Prairie Island Nuclear Generating Plant Units 1 and 2  
Dockets 50-282 and 50-306  
Renewed License Nos. DPR-42 and DPR-60

Supplement to 10 CFR 50.55a Requests (RR) 1-RR-5-2 and 2-RR-5-2 (TACs MF4835 and MF4836) Associated with Prairie Island Nuclear Generating Plant (PINGP) Fifth Ten-Year Interval Inservice Inspection (ISI) Program

### **Supplement to 10 CFR 50.55a Requests (RR) 1-RR-5-2 and 2-RR-5-2 Associated with Prairie Island Nuclear Generating Plant (PINGP) Fifth Ten-Year Interval Inservice Inspection (ISI) Program**

Figure 2 (NF-38215-16)

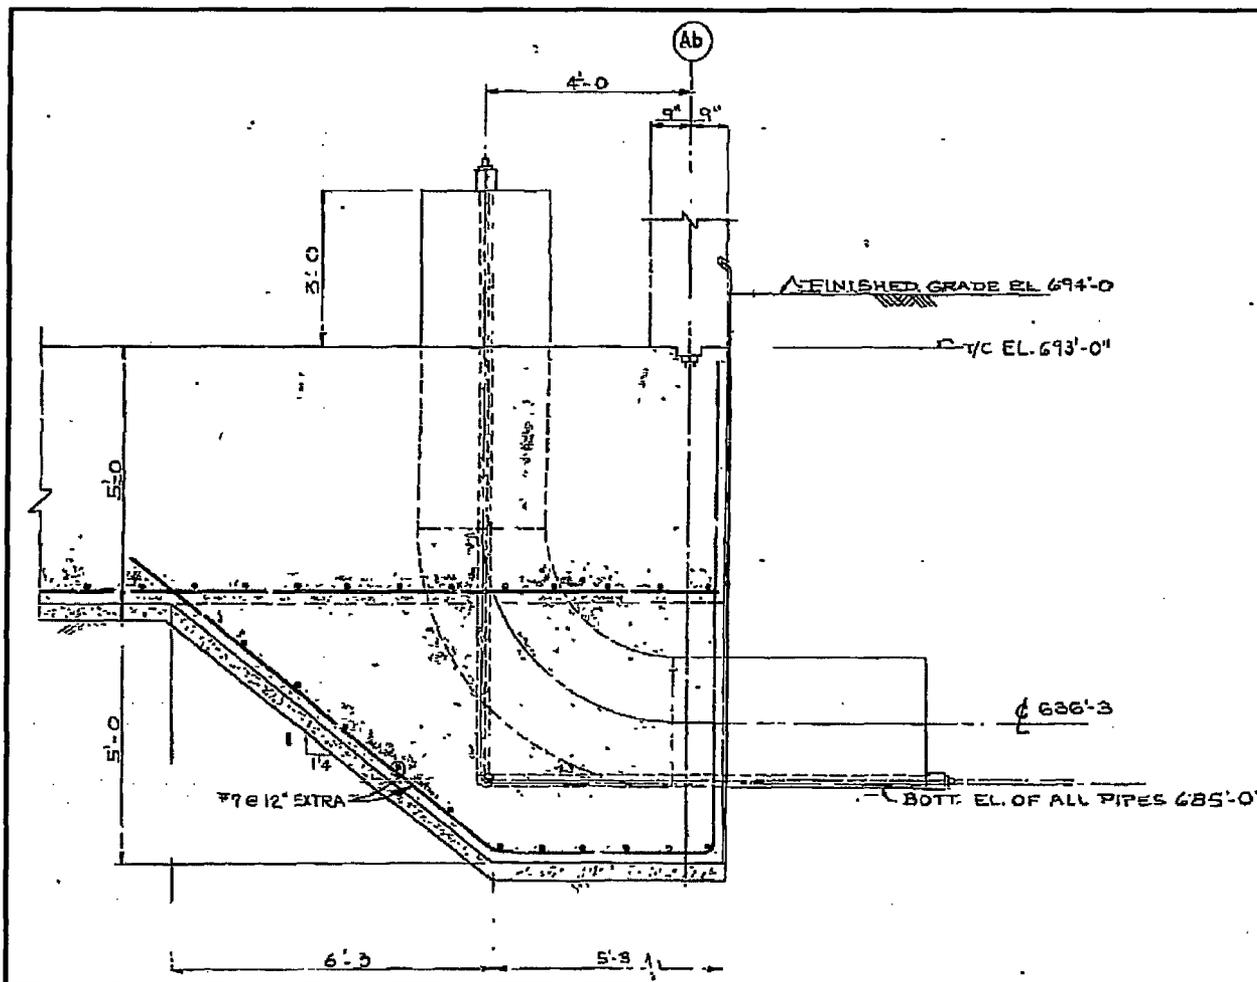
- (1) buried in the yard (outside of the buildings);
- (2) buried under various buildings (i.e., administration building, screen house, and turbine building) where the pipe segments are inaccessible for visual examinations; and
- (3) above ground

- (2) The two CL headers penetrate the Screenhouse horizontally through pipe sleeves in the 3 feet 6 inches thick vertical concrete wall into the soil in the yard. The headers go south for approximately 67 feet until they go under the Administration Building. They transverse under the Administration Building for approximately 22 feet and under the Turbine Building an additional 4 feet where they elbow vertically and come

up through floor penetrations in the Turbine building near Column Row Ab (see Figure 2 from drawing NF-38215-16 above). Approximately 26 feet of each CL header are under the Administration and Turbine Buildings with an additional 3.5 feet in the Screenhouse wall penetrations. Therefore, approximately 29.5 feet of each header is buried under buildings and not readily accessible.

**FLOW DIAGRAM**  
**COOLING WATER - SCREENHOUSE**  
**UNIT 1 & UNIT 2**  
 NF-39216-1

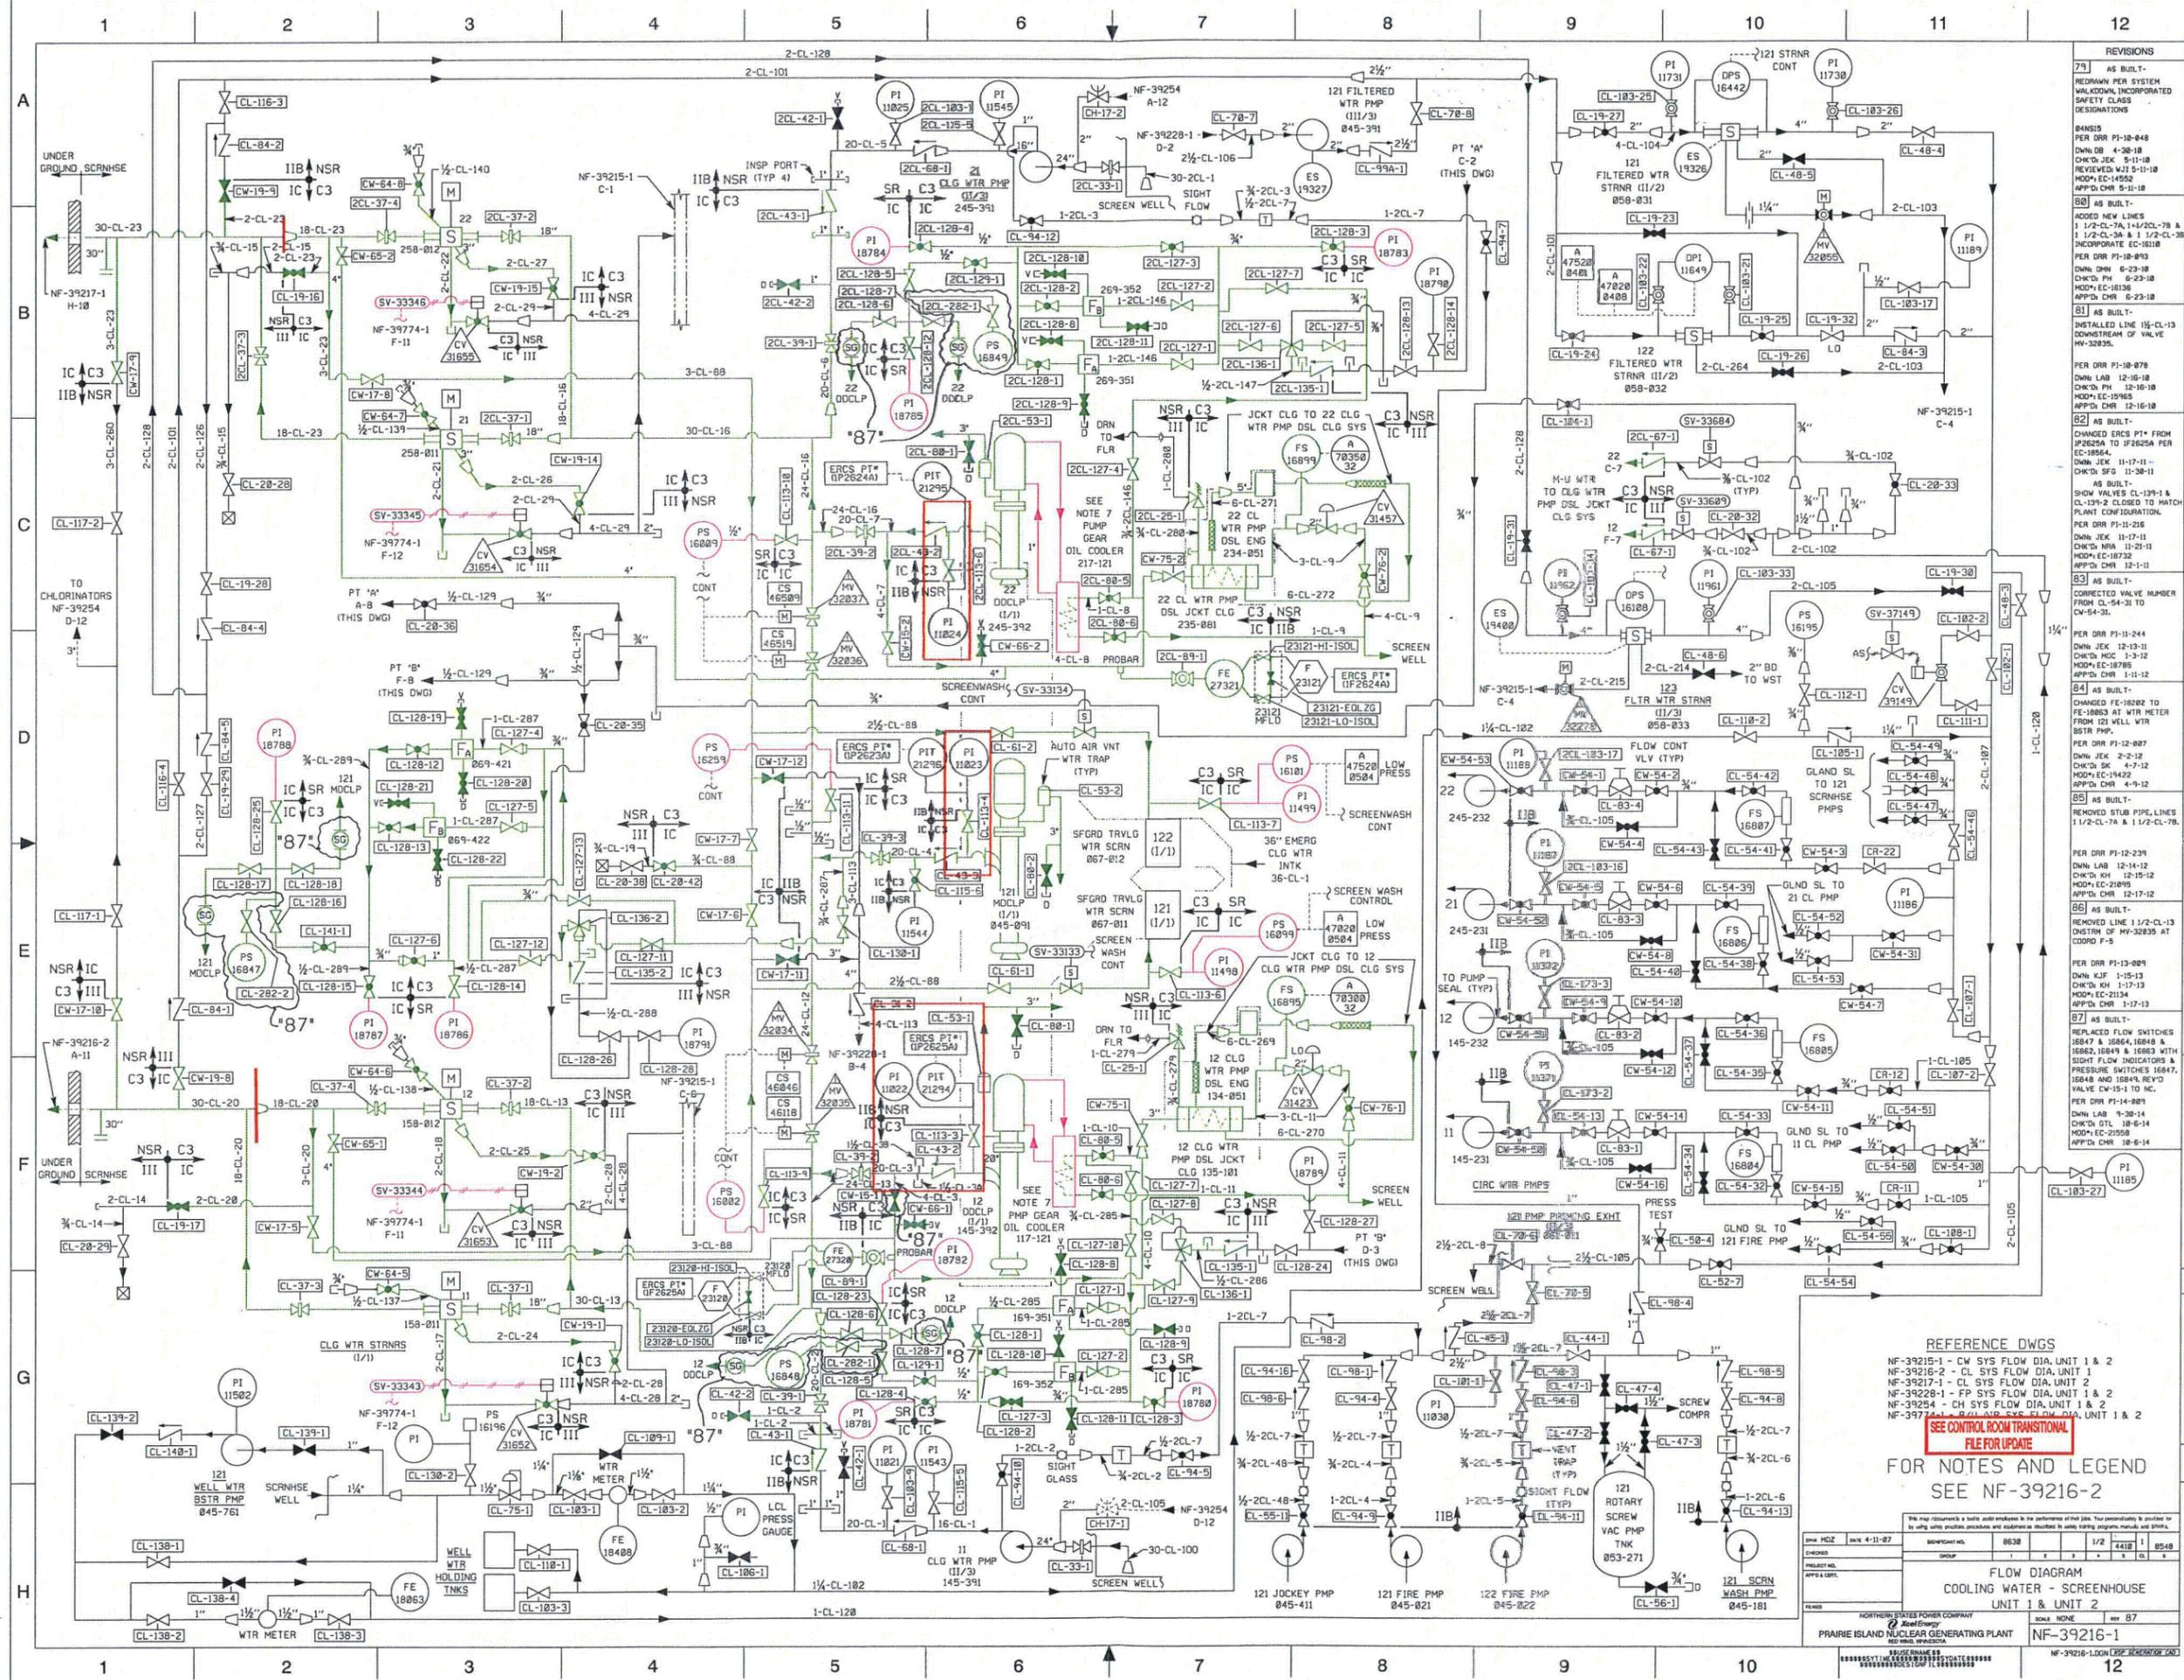
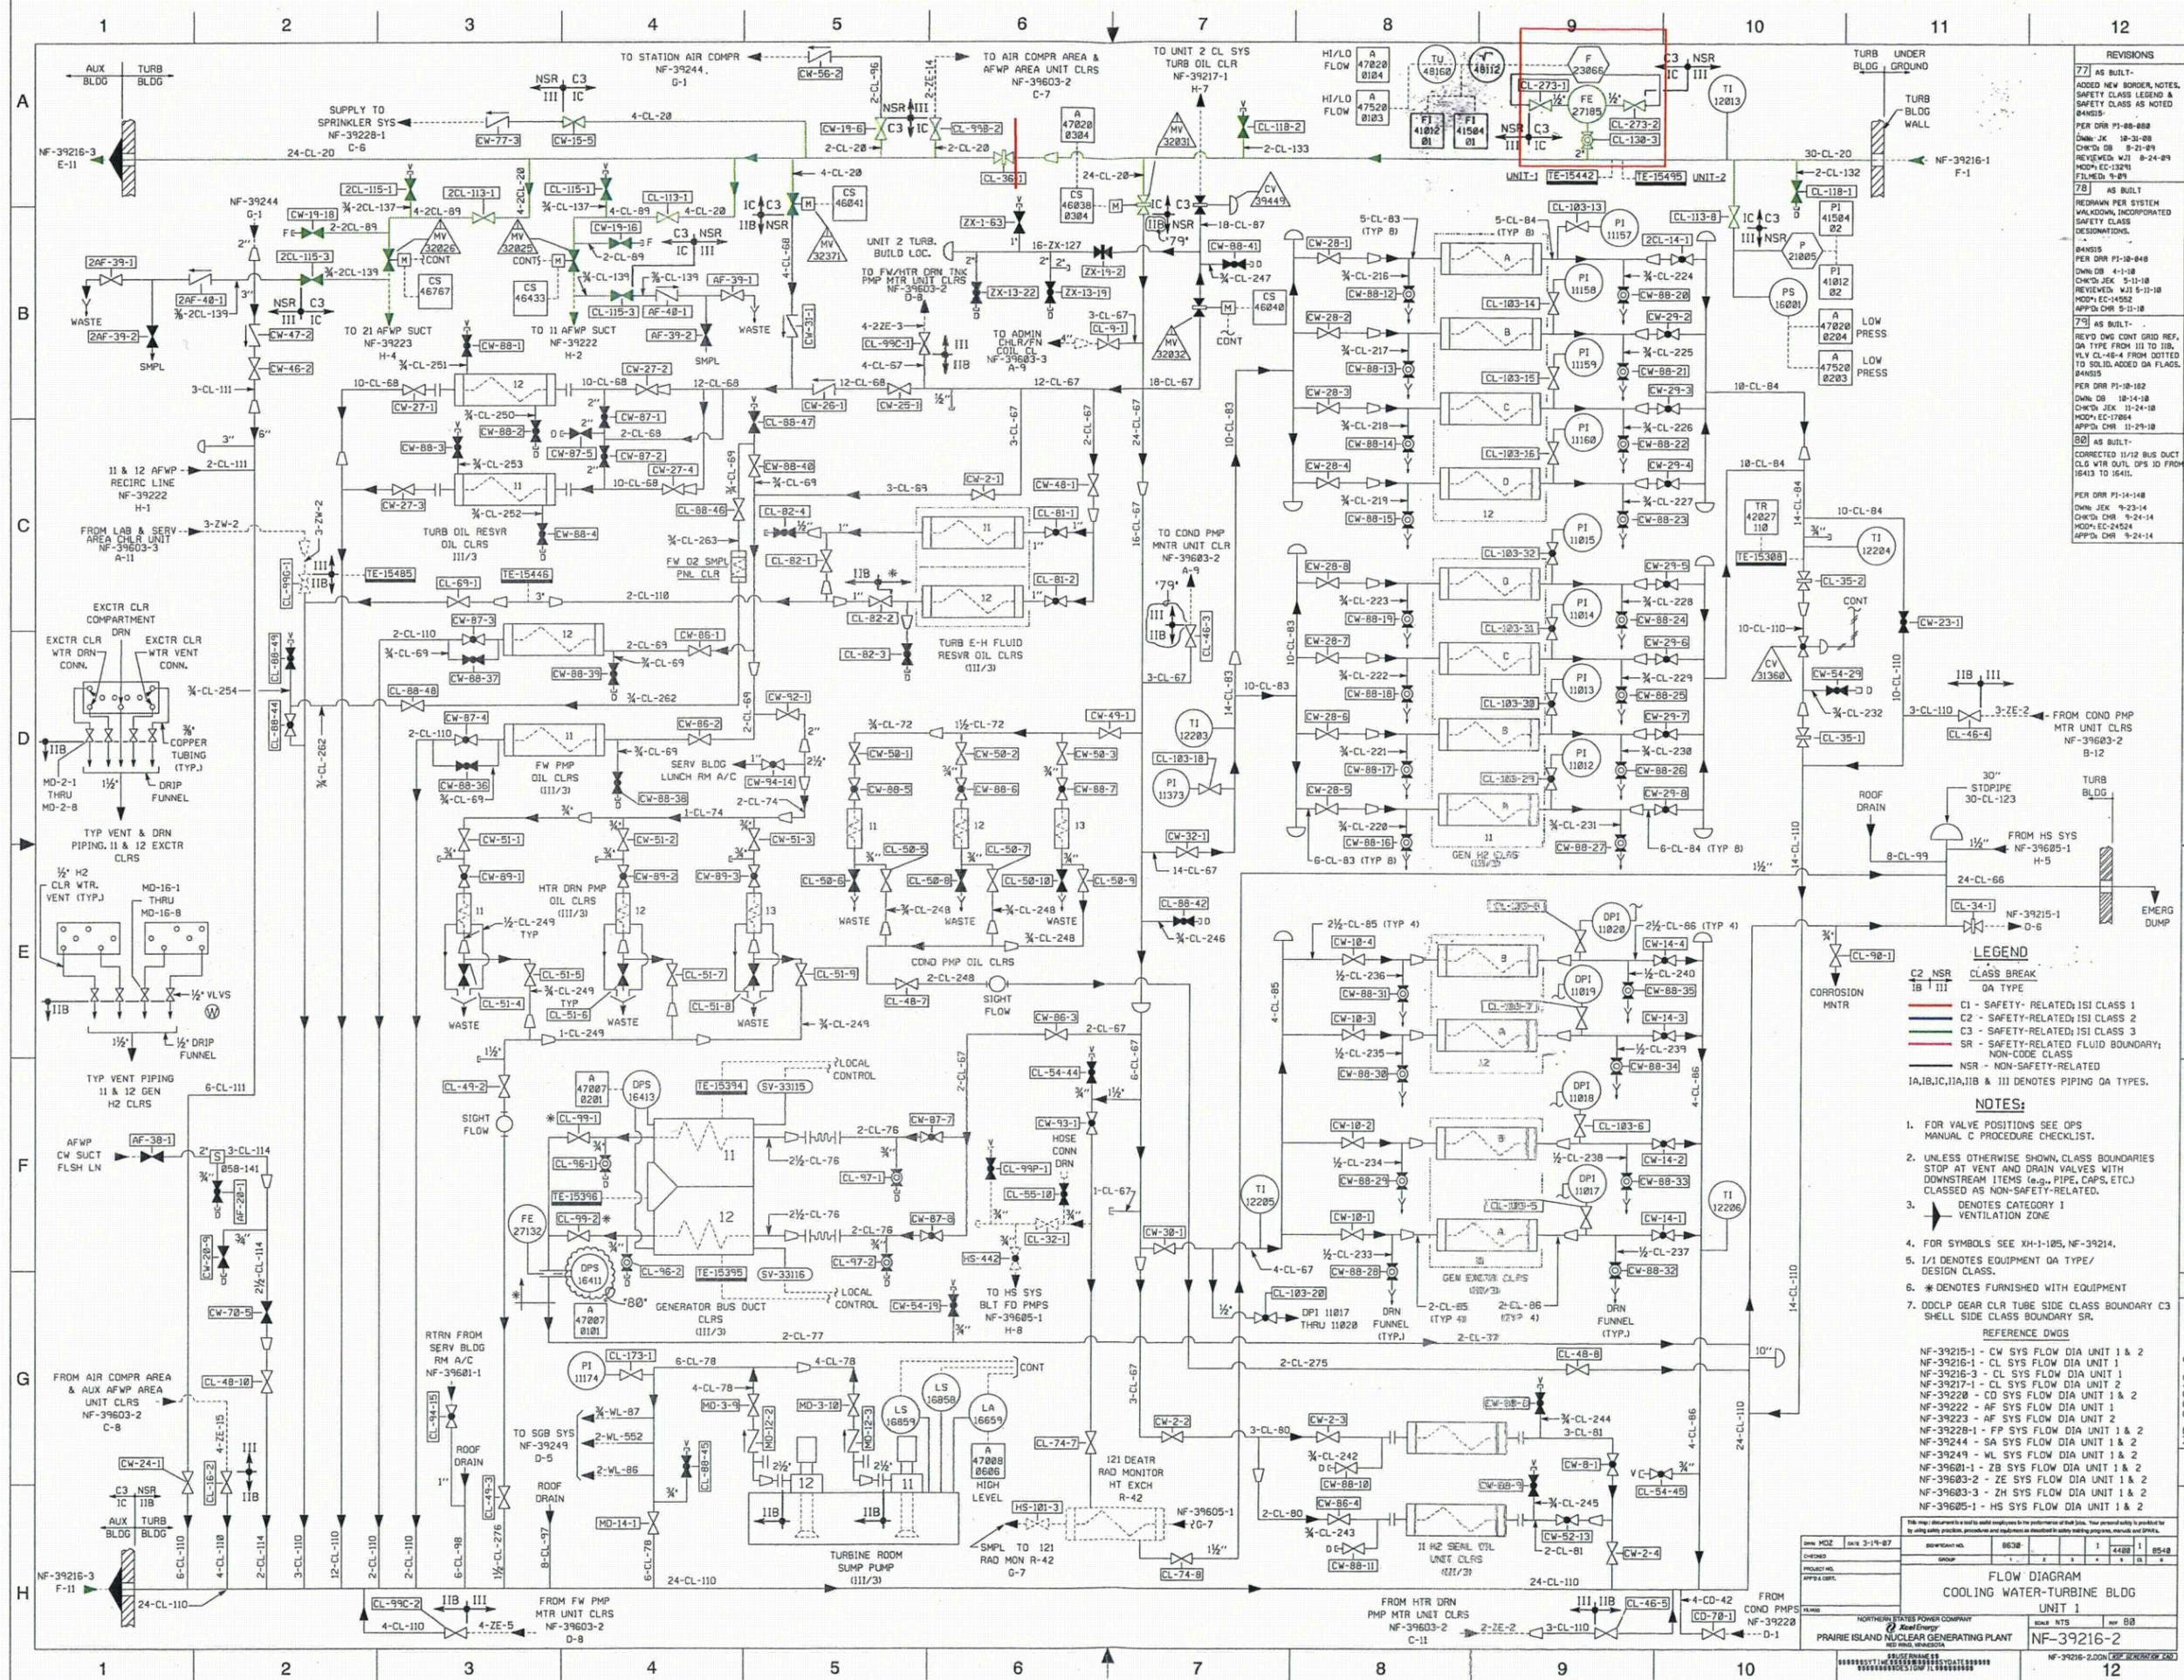
Provide a piping and instrumentation diagram (P&ID) and piping isometrics that contain the cooling water system (CL). A hand-sketch of the subject piping would also assist the NRC staff to understand the pipe boundaries and proposed pressure tests. On these drawings, please identify the boundary of CL lines 30-CL-20 and 30-CL-23; the direction of the coolant flow so that the suction pipe and discharge pipe are identified; the pipe segments that are buried under buildings and the pipe segments that are buried in the yard (outside of the buildings); and the locations of flow meters and pressure sensors.

(a) Clarify what is significance of a flow meter located in the turbine building in terms of detecting potential pipe leakage and where exactly is the flow meter located at the downstream of the buried piping. As requested in RAI-RR-2-1 (a), a diagram showing the locations of the flow meter along the CL piping would assist in clarifying this question.

The requested information is shown on NF-39216-1 (Flow Diagram Cooling Water – Screenhouse Unit 1 & Unit 2), NF-39216-2 (Flow Diagram Cooling Water – Turbine Building Unit 1), NF-39217-1 (Flow Diagram Cooling Water – Turbine Building Unit 2) and a Simplified CL System Diagram provided as Attachments 1, 2, 3, and 4, respectively, to this Enclosure.

The boundary of line 30-CL-20 is shown on NF-39216-1 and NF-39316-2 with a red line. The boundary of 30-CL-23 is shown on NF-39216-1 and NF-39217-1 with a red line. The direction of the cooling flow is indicated on the P&ID with arrows. Pressure indication and flow meters are notated on NF-39216-1, NF-39216-2, and NF-39217-1 with red rectangles. The pipe segments that are buried are shown on Figure 1 below.

Flow element FE-27185 is located at elevation 710'6", at approximately plant Column/Row Ab-8. Flow element FE-27186 is at the same elevation and similar location (Ab-10). The 12, 22, and 121 CL safeguards pumps and associated discharge pressure indication are located in the Plant Screenhouse, and connected to the Turbine Building through buried piping. The flow elements are downstream of the buried piping, inside the Turbine Building (NF-39216-1, NF-39216-2 and NF-39217-1 (Attachments 1, 2 and 3 respectively)).
